Subject: Peach Bottom Atomic Power Station, Unit 2
Response to Request for Additional Information Regarding
Technical Specifications Change Request No. 93-02 (ASD RAI-4)
and Supplemental Information Concerning Our Response to
Request for Additional Information (ASD RAI-3) submitted
August 17, 1994

**RESPONSE TO REQUEST FOR ADDITIONAL INFORMATION (ASD RAI-4)
Peach Bottom Atomic Power Station, Unit 2**

PBAPS RPT LOGIC

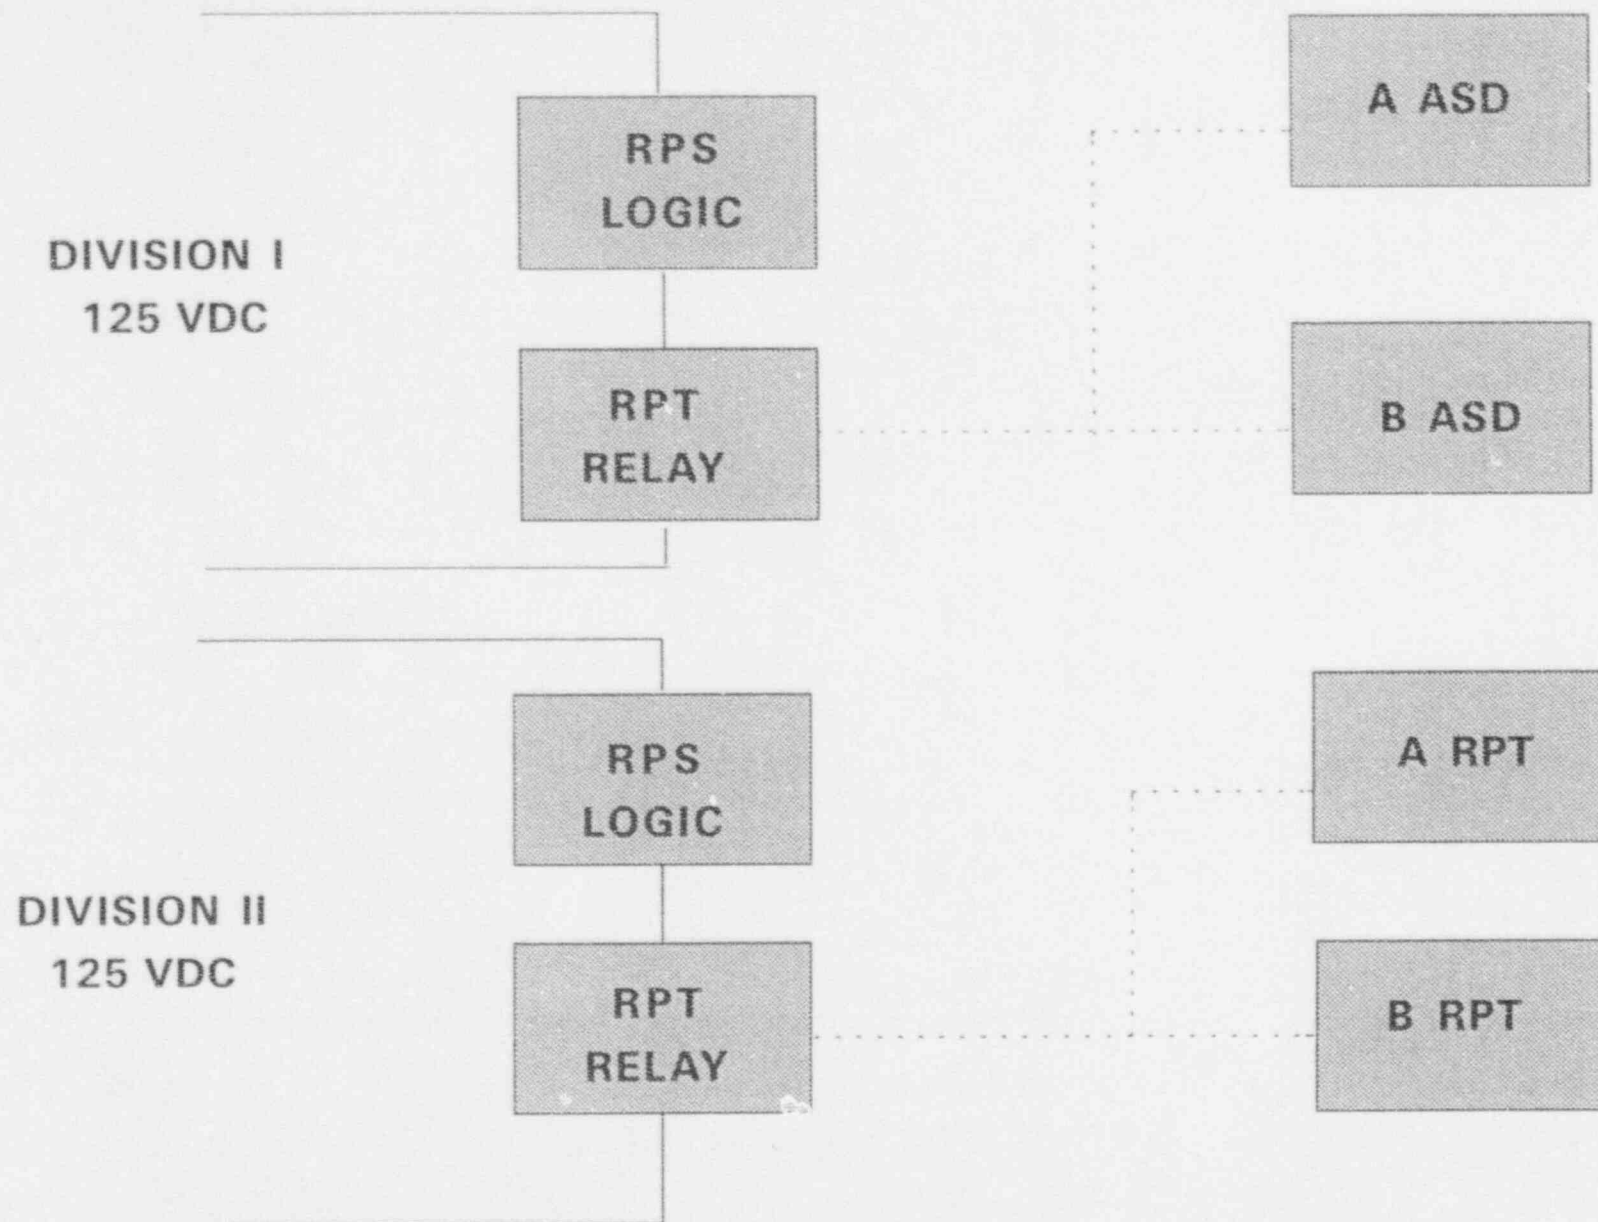
The MCPR-RPT System logic is powered from safeguard 125 VDC sources, and the cables are run in separate, rigid steel conduits in order to meet electrical separation requirements. There are two independent trip systems which actuate diverse trip mechanisms in the MCPR-RPT System; one system trips both the RPT breakers, and the other trips both Adjustable Speed Drives (ASDs). Therefore, the MCPR-RPT System is considered highly reliable. Refer to attached block diagram for a representation of the MCPR-RPT System.
